## AMENDATORY AGREEMENT

**SUBJECT: High Line Canal Trail Change Order**

**PROJECT: High Line Canal Trail Underpasses – Hampden/Colorado (201629357)**

As Constructed	HLC TRAIL - HAMPDEN/COLORADO HAMPDEN UNDERPASS EXHIBIT	
No Revisions:	Designer: EMG	Structure Numbers
Revised:	Detailer: SPC	
Void:	Sheet Subset: TRAIL	Subset Sheets: TR 6 OF 21

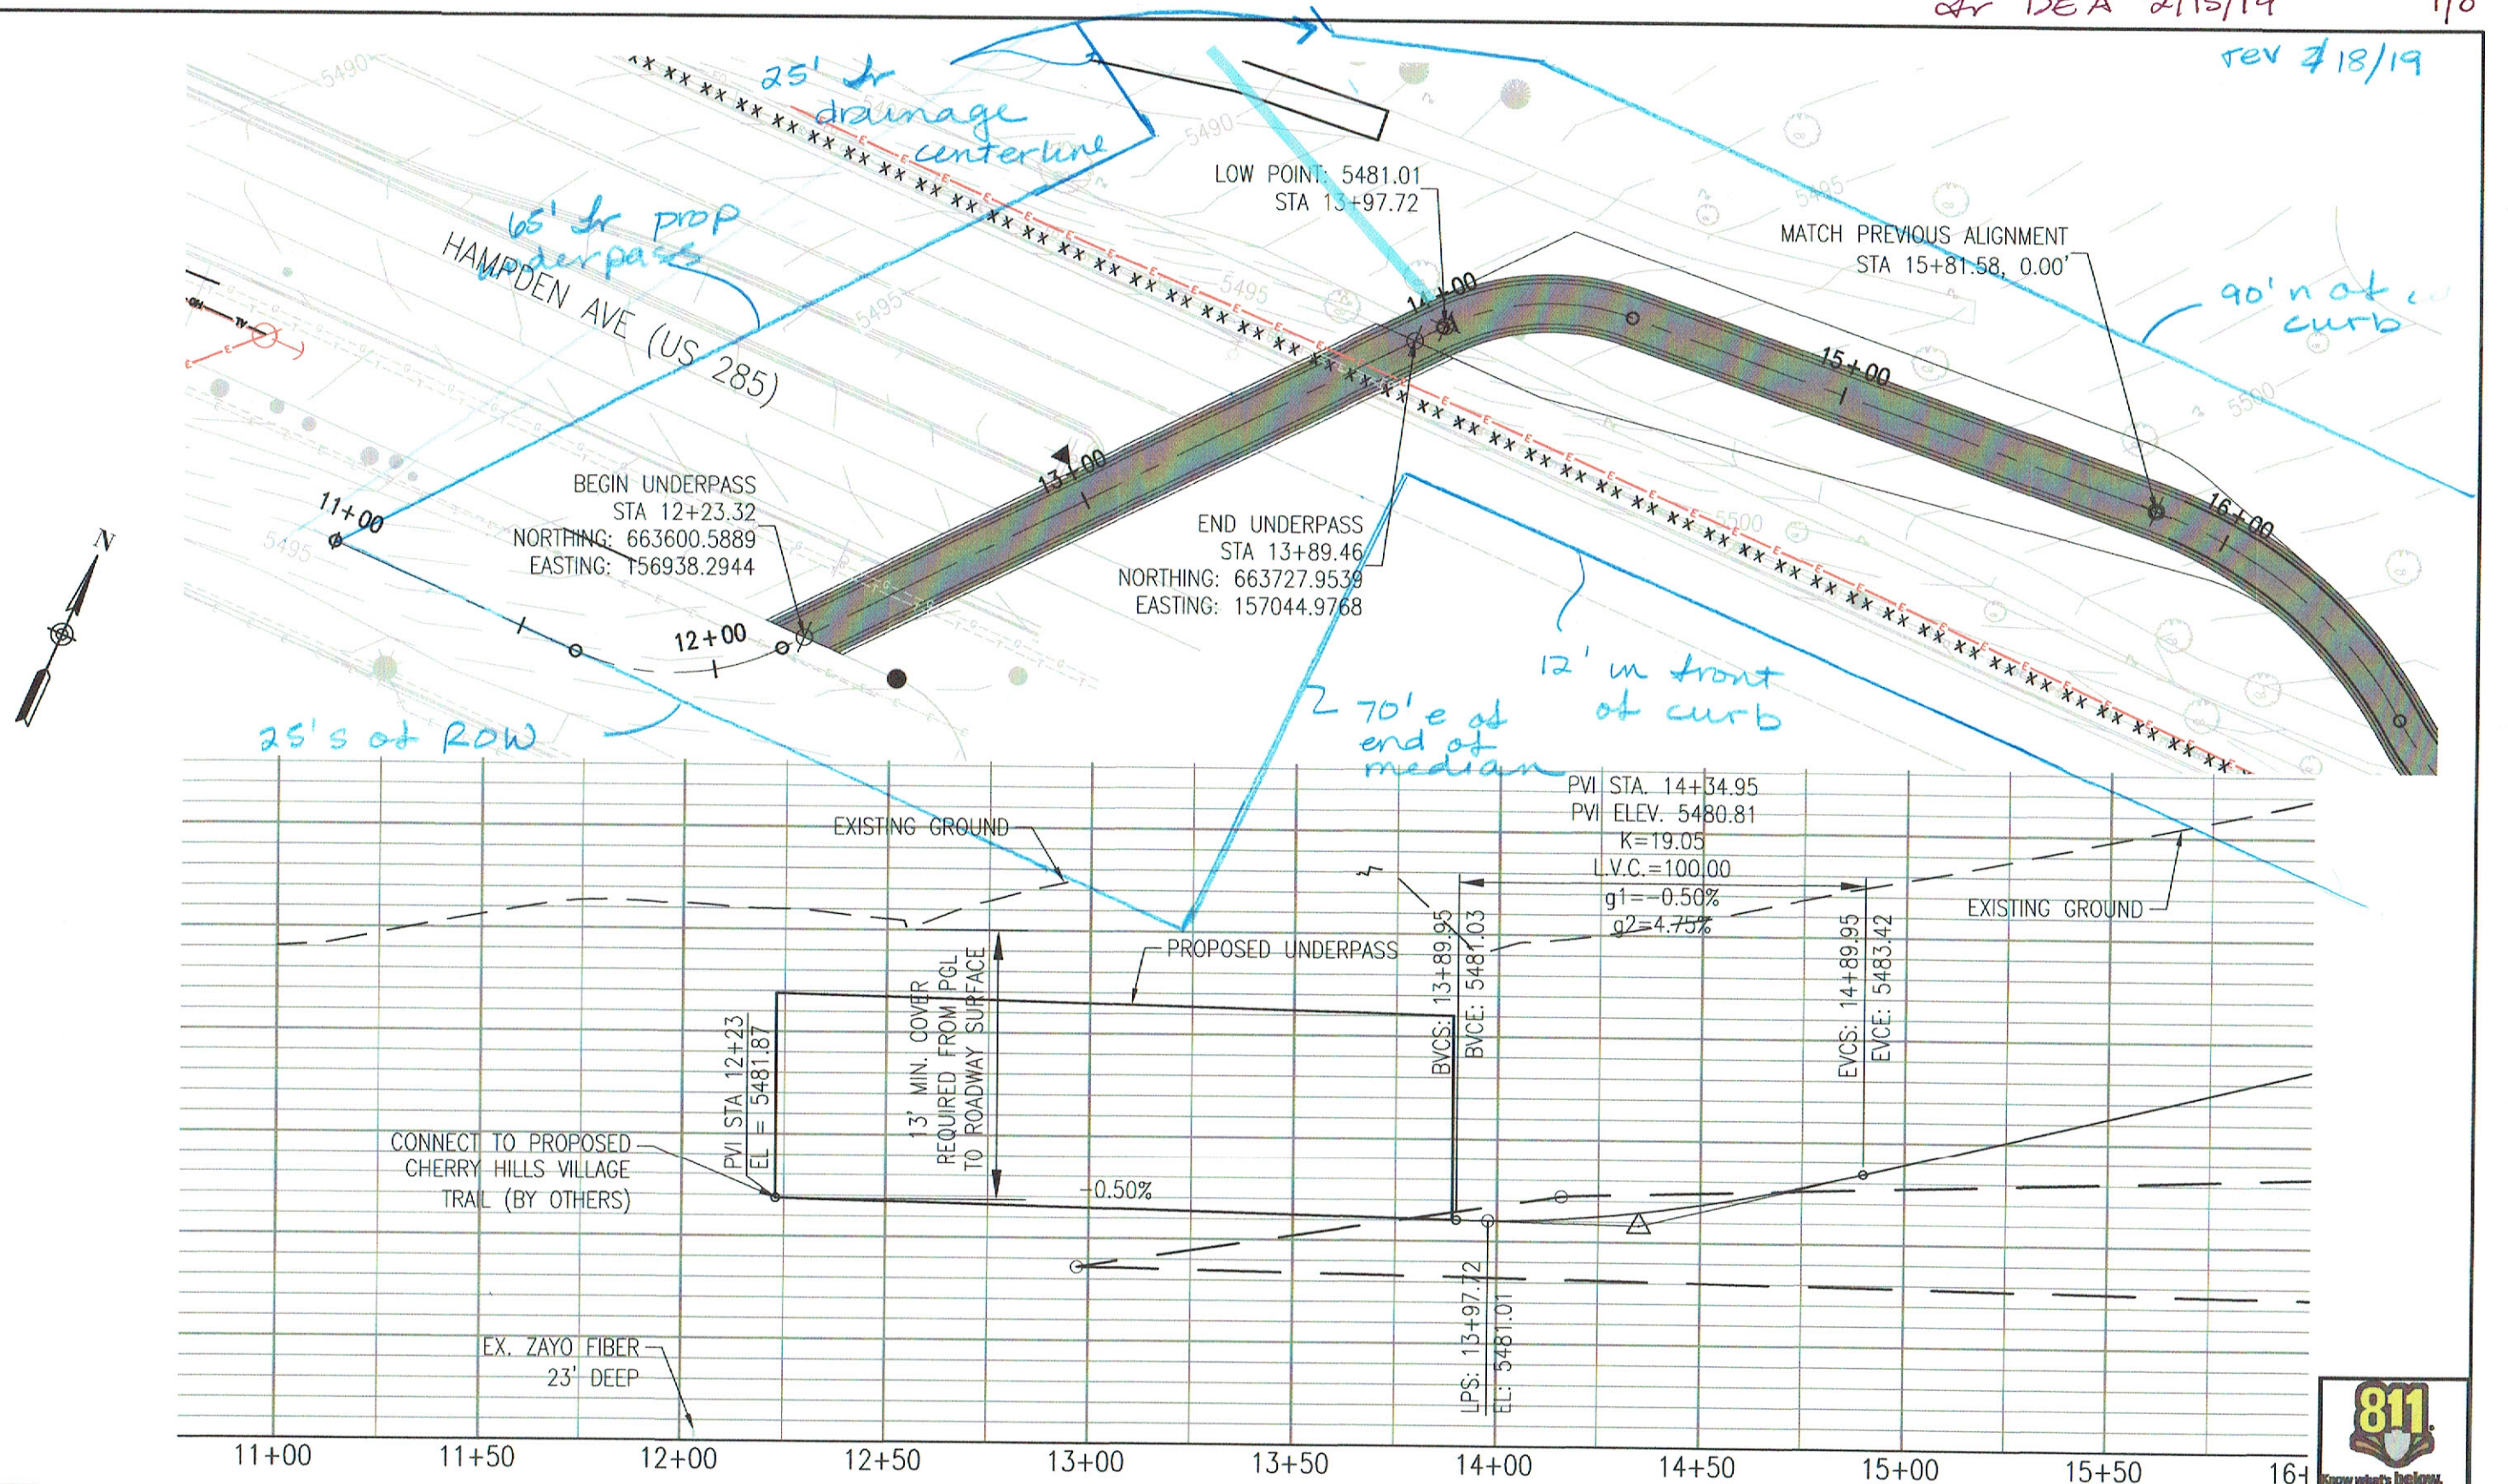
- Relocation of the Hampden Ave Underpass based on coordination with Cherry Hills Village requiring revisions to both our 30% documents and Draft 90% documents including additional topographic survey and geotechnical borings (affected parties: DEA, Yeh, HKS)

This letter presents Yeh and Associates, Inc. proposed scope of work and estimated project costs for providing additional geotechnical services. We understand the location of the proposed box culvert has moved to the east approximately 150 to 200 feet of the previous design location. As a result, two additional geotechnical borings are needed. The following additional services are proposed.
